Our Ref: TR/11577

10 February, 2021

RE: DEE WHY 7-ELEVEN PETROL STATION RESPONSE TO MATTERS RAISED BY TINSW

AMENDED SITE PLAN

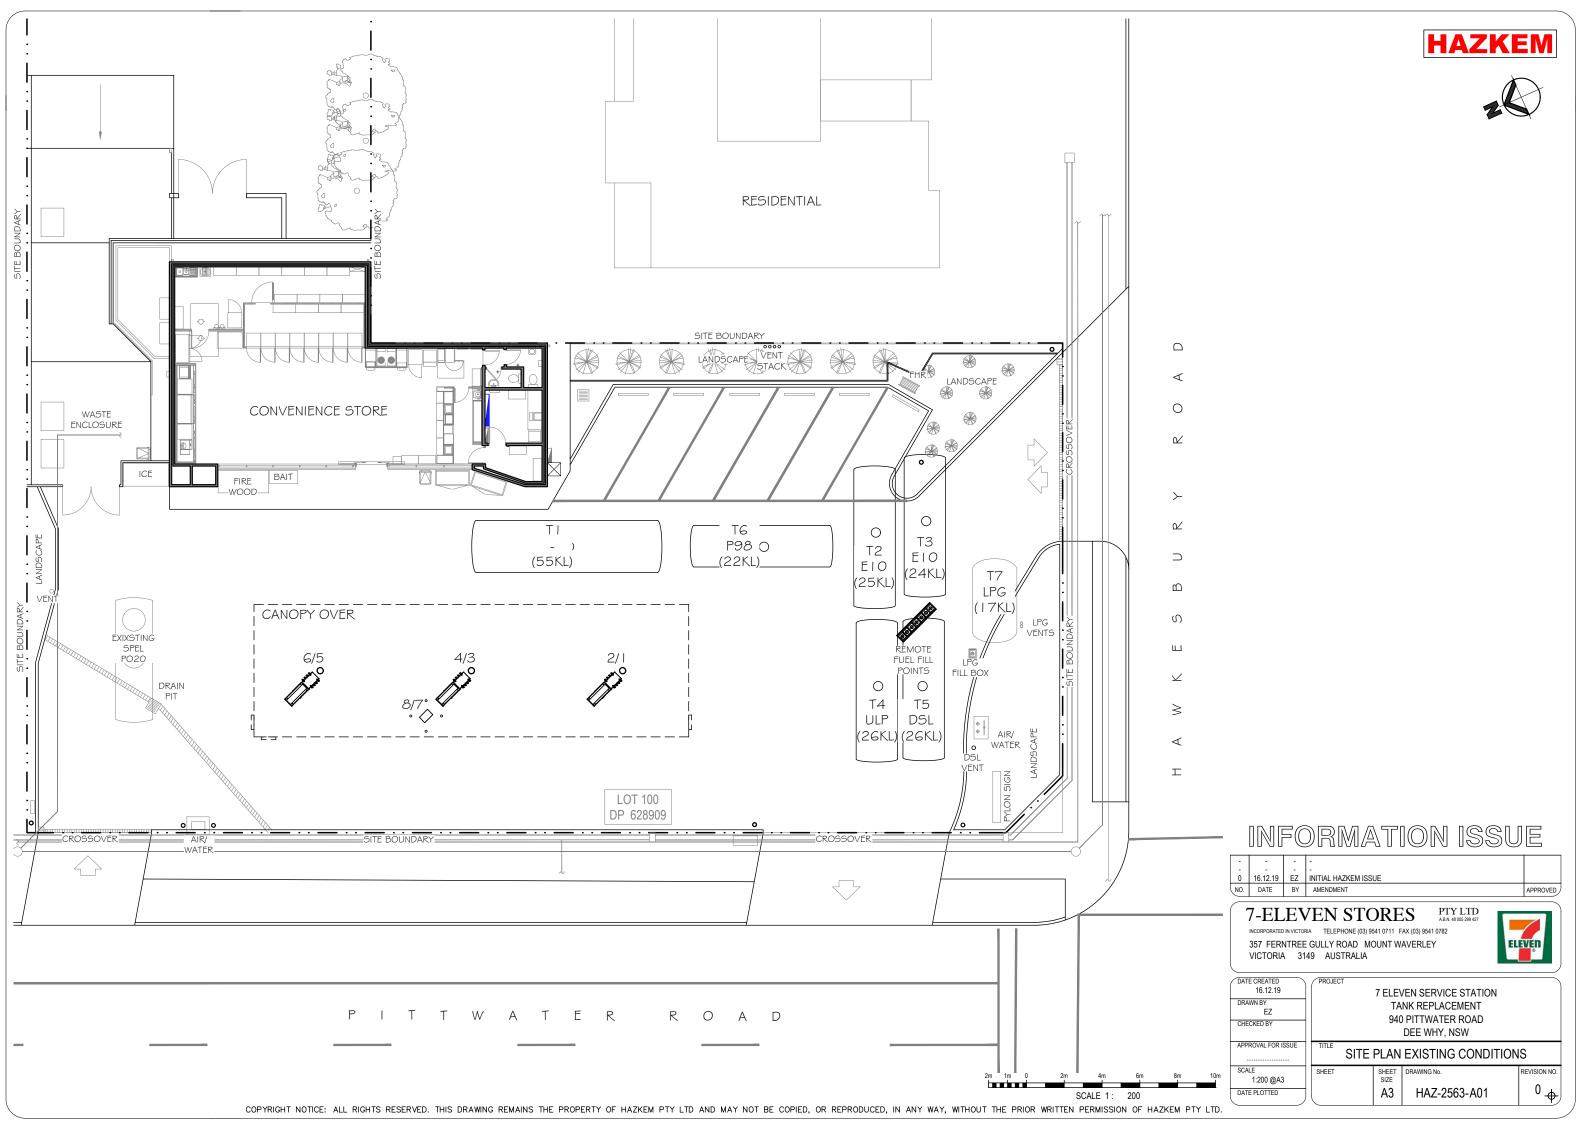
- i. The submitted plans indicate that the tanker will be blocking two traffic lanes on Pittwater Road within close proximity to the signalized intersection, whenever they are required to wait for vehicles to exit at the proposed entry/exit driveway on Pittwater Road. It is requested that this driveway is changed to 'entry only' to address this concern. All vehicles should exit onto Hawkesbury Road

- ii. Another option might be for the proponent to consider widening the first entry driveway on Pittwater Road for the tankers. However, this depends on whether the swept path analysis demonstrates that tankers can enter on Pittwater Road and exit on Hawkesbury Road in a forward direction

- tanker deliveries would occur between when the petrol station is not busy, between 12.00am and 6.00am:
- the tanker would enter the site via the northern driveway on Pittwater Road, park on the southern part of the site, unload fuel and then exit via a left turn onto Hawkesbury Avenue;

- the northern driveway will be widened (as suggested in the second point of the TfNSW letter). The required widening is shown on the plan provided in Attachment A; and

- between I2.00am and 6.00am (or after the tanker has entered the site), the fuel pumps on the northern side of the northern bowser would have "not use signs" and cones would be placed on the northern side of this bowser (to stop cars parking on this side of the bowser). This is to keep this area clear so that the tanker can travel through the site.
